# Dry Creek Watershed Plan Update

## Design Memorandum

RE: Dry Creek Watershed Plan Update

**Project Name and Number:** 29001 Dry Creek Watershed Project  
**Client Name:** Civil Engineering Solutions, Inc.  
**Contact Person:** Thomas Plummer, Jr., P.E.  
**Email Address:** [Thomasplummer@civilsolutions.org](mailto:Thomasplummer@civilsolutions.org)  
**Phone Number:** (916) 563-7300      **Fax:** (916) 563-7362

**Site A:**  
**Antelope Creek Upstream of Atlantic Street**

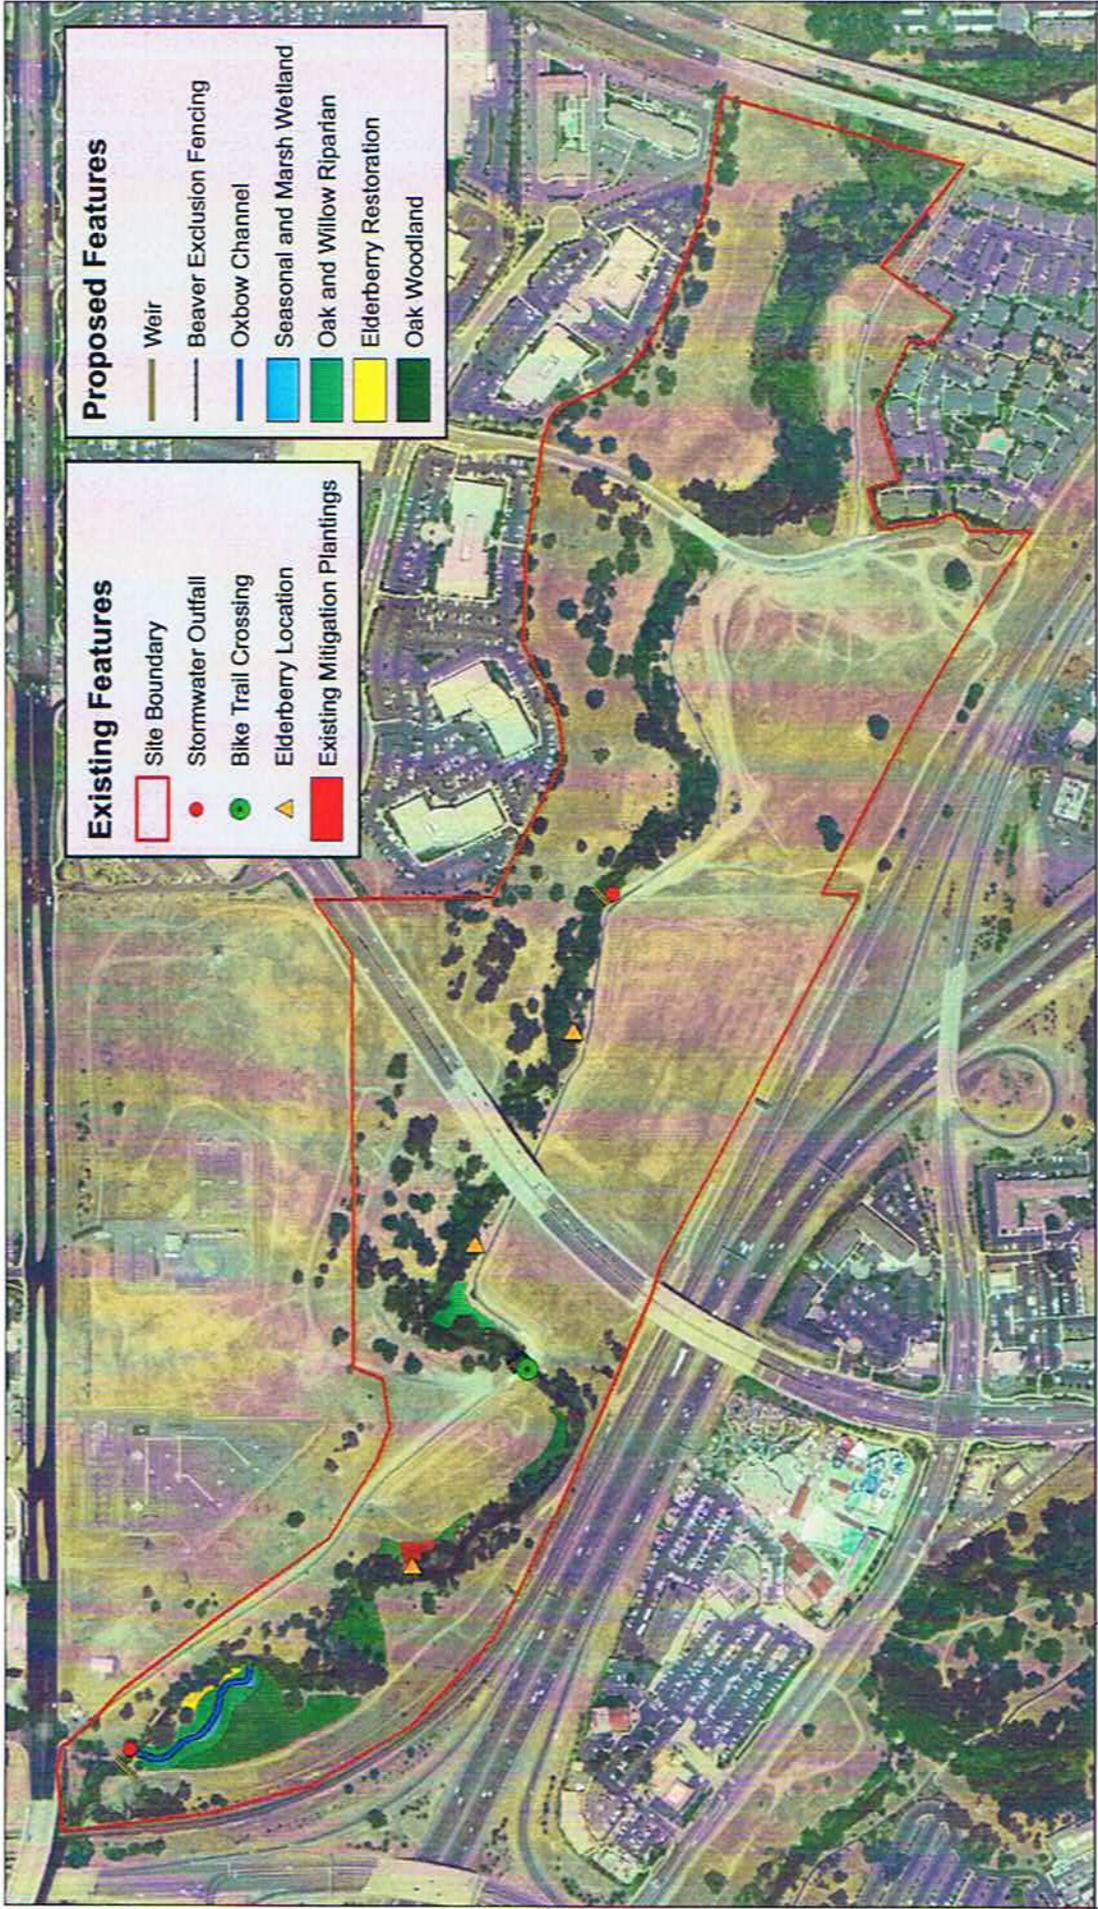
*Site Constraints:* The proposed location for Weir #1 is constrained by an existing underground gas line and a sewer line. We believe that the location of the weir should be moved upstream of the gas line and sewer line access manhole and downstream of the existing storm drain outfall bringing runoff from the base of the railroad grade and adjacent capped landfill site to Antelope Creek. The weir should tie into the existing berm covering the sewer line and be constructed in a manner to allow room on the downstream side of the proposed weir for access to the sewer line where it crosses under the creek or railroad grade for future maintenance needs. The weir should also be constructed so that the spillway elevation is below the sewer line elevation to avoid flooding into the manhole. On the downstream side of the proposed weir we recommend that the earthen fill covering the existing gas line be provided with rock armor over geotextile fabric to provide erosion protection from peak flows, especially those that overtop the proposed weir. The existing maintenance road for the sewer line and landfill site could provide excellent all weather vehicular access to the weir for construction and on-going maintenance operations.

*Habitat Restoration Opportunities:* As can be seen in our Opportunities and Constraints map in Appendix A, we propose an "Oxbow Channel" be constructed in the open area east of Antelope creek just upstream of Weir #1 and identified by RBF Consultants as being within the area of inundation during storm water detention periods. This portion of the existing Antelope Creek floodplain does not currently support wetlands nor oak or riparian habitat likely a result of capping the adjacent landfill site. The created "Oxbow"

A small cluster of elderberry shrubs was also found in this area between the creek and the “oak orchard”. These shrubs may be at risk of mortality if they are flooded with any frequency or for any duration as a result of the construction of Weir #1. The elevation of the root crowns of these plants should be determined and the potential flood regime established during final resource assessments if the project is to proceed. Transplantation of these shrubs may be possible, but we recommend against it in order to protect the existing stream bank and propose instead planting additional elderberry shrubs on the upland islands created as a part of the “Oxbow” downstream.

*Opportunities:* We believe that Weir #2 should be created by simply removing the beaver dam at the service road/bike trail overcrossing and lowering the existing static

water level to create additional storage volume upstream of the existing barrier. Obviously, removal of the beaver dam is a temporary fix and therefore it would have to be followed by a well designed beaver proof inlet to existing culverts passing stream flows under the service road/bike trail overcrossing. Furthermore, beavers in this reach must be controlled through trapping by experts under a CDFG depredation permit. The City of Roseville currently works with trappers from the Placer County Agricultural Department to remove beavers from the Dry Creek Watershed and this site could be made one of critical importance to all concerned in order to ensure the storm water detention value of the existing structure. We feel that this alternative to a new weir structure could provide significant detention at minimal cost.

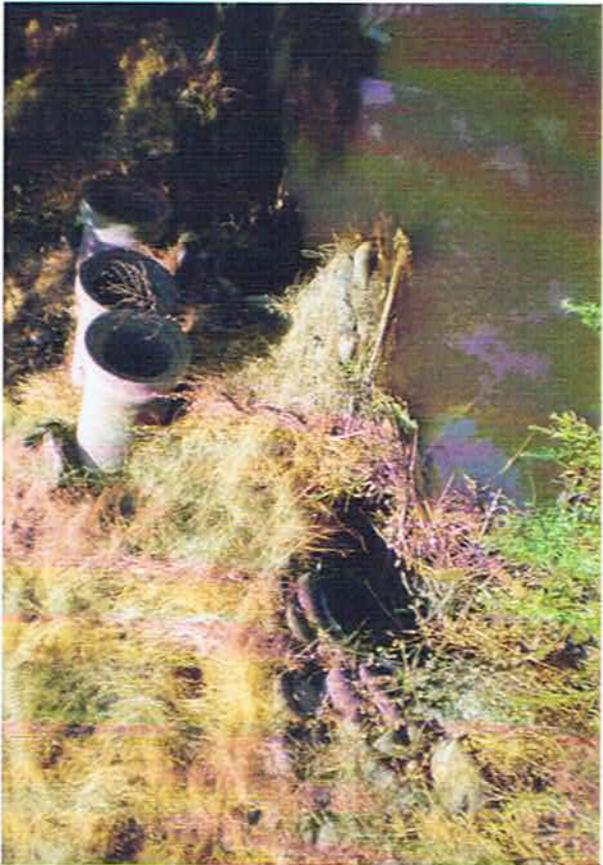
Site A: Large valley oak within the flood zone. Attention should be given to weir design and duration of flood up to prevent detriment to existing protected vegetation.

Site A: Parrots feather and concrete outfall. Noxious non-native vegetation should be treated and removed as part of the riparian enhancement.

Site A: Open Floodplain on downstream end of Antelope Creek. We suggest this site be used for wetland restoration ("Oxbow").

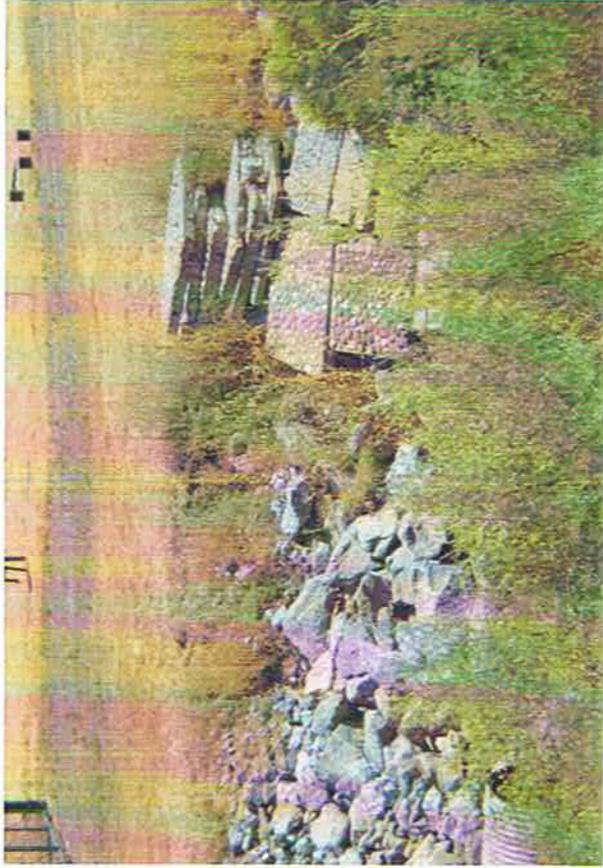
Site A: Existing Mounds of soil along Antelope Creek may be enhanced and created elsewhere on site to provide hydrologic/soil conditions for elderberry plantings.

Site A: Red sesbania. Noxious non-native vegetation should be treated and removed as part of the riparian enhancement.

Site A: Himalayan blackberry. Noxious non-native vegetation should be treated and removed as part of the riparian enhancement.

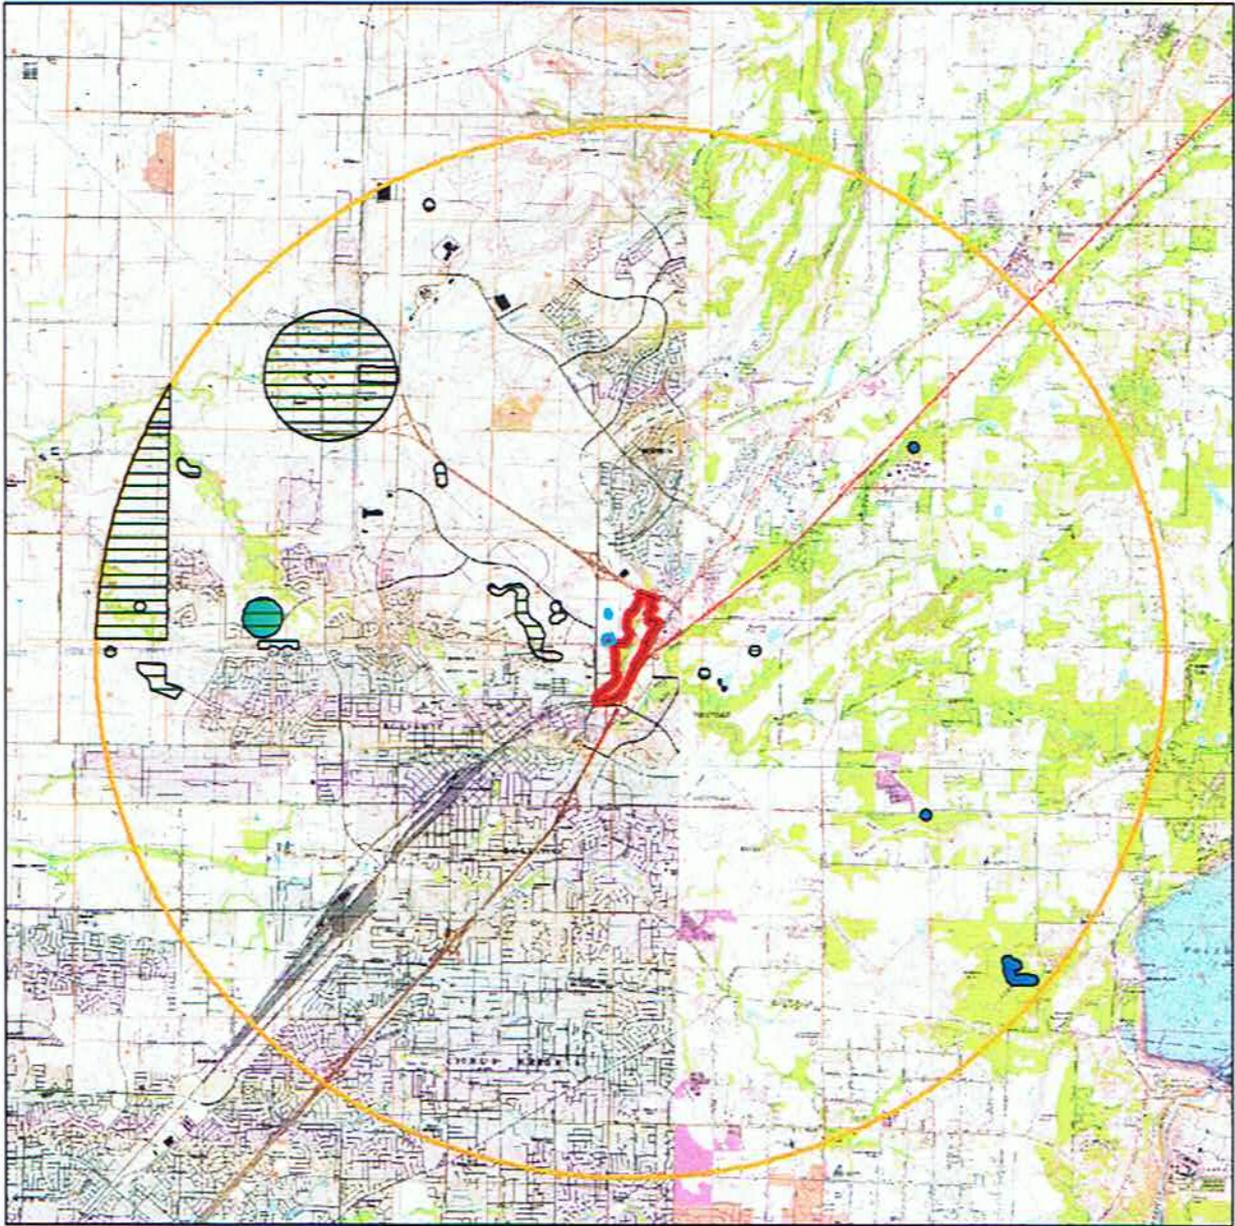
Site A: Bike trail crossing inlet. Pipes should be cleared and maintained. We suggest a beaver exclusion device be installed upstream of this location

Site A: Bike trail crossing outlet. It is suggested that concrete slabs be removed and disposed of legally off site or used for upland habitat structures.

Site A: Oak tree mitigation plantation. There is a location on Antelope Creek that has been used for what seems to be oak tree mitigation plantings.

Site A: Oak tree mitigation plantation. Trees were planted in dense rows discouraging the development of a diverse and appropriately structured oak riparian woodland

Site A: Lower benches. Adjacent to the oak tree mitigation site at the base of the capped landfill there are sites suitable for additional oak plantings.

Site A: Lower benches. There are multiple locations along Antelope Creek at the base of the capped landfill that are suitable for oak tree mitigation plantings.

**Exhibit 2**  
**Potential Project**  
**Linda Creek upstream Auburn-Folsom Road**

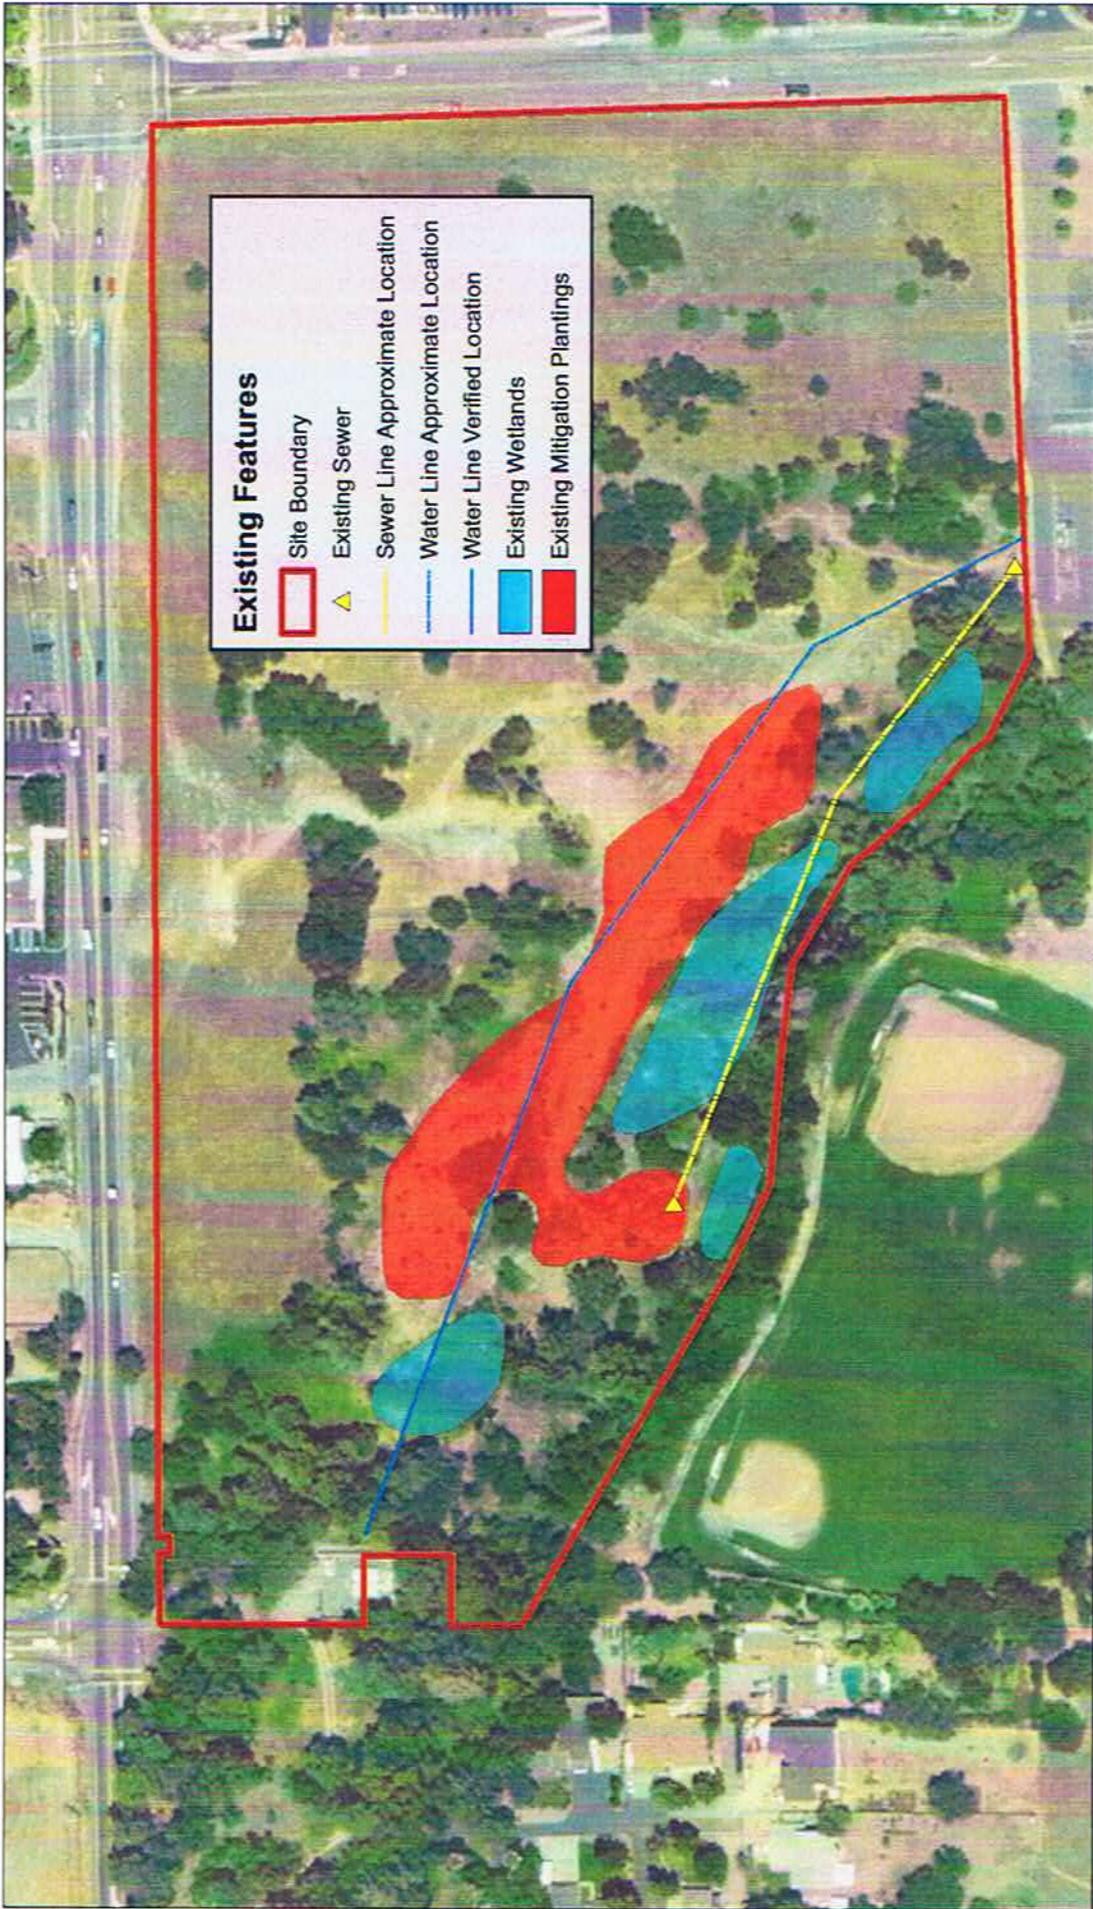
Prior to our visit to Site C, the Client and RBF Consulting provided a schematic drawing overlaying an aerial photograph of the site. The potential project indicated on this drawing proposes a berm be constructed along the left bank of the Linda Creek tributary and an off-channel detention basin be constructed encompassing something more than the southerly one third of the site. No information is given on the drawing regarding neither the height of the proposed berm nor the depth of the proposed basin. Restoration Resources gathered supporting data and maps and proceeded in the field to verify the constructability and potential constraints to the implementation of the proposed detention facility.

Upon entering the site it was immediately evident that there are multiple existing wetland features and mature oak-dominated riparian vegetation all along the Linda Creek tributary, as well as, significant stands of oak-dominated woodlands throughout the proposed work area. Impacts due to proposed construction to the existing oaks alone would create extensive and expensive mitigation requirements. It should be noted that the site is currently being used as an oak and/or riparian mitigation site (irrigation lines and tree posts supporting installed native riparian trees were found all along the right bank of the tributary). There are also existing sewer lines and manhole covers as well as existing water pipelines paralleling the creek within the proposed area of work. The only area that could potentially be appropriate for a storm water detention basin is the northerly half of the site and it is at an elevation relative to the creek thalweg such that the ability to create a floodwater detention facility at this site seems impractical not to mention that any diversion facility and return facility would have to cross existing sewer and water lines. It is our opinion that the net benefit of creating a detention basin and berm on this site would not exceed impacts associated with the construction. Therefore we do not recommend the use of this site for a flood water detention facility.
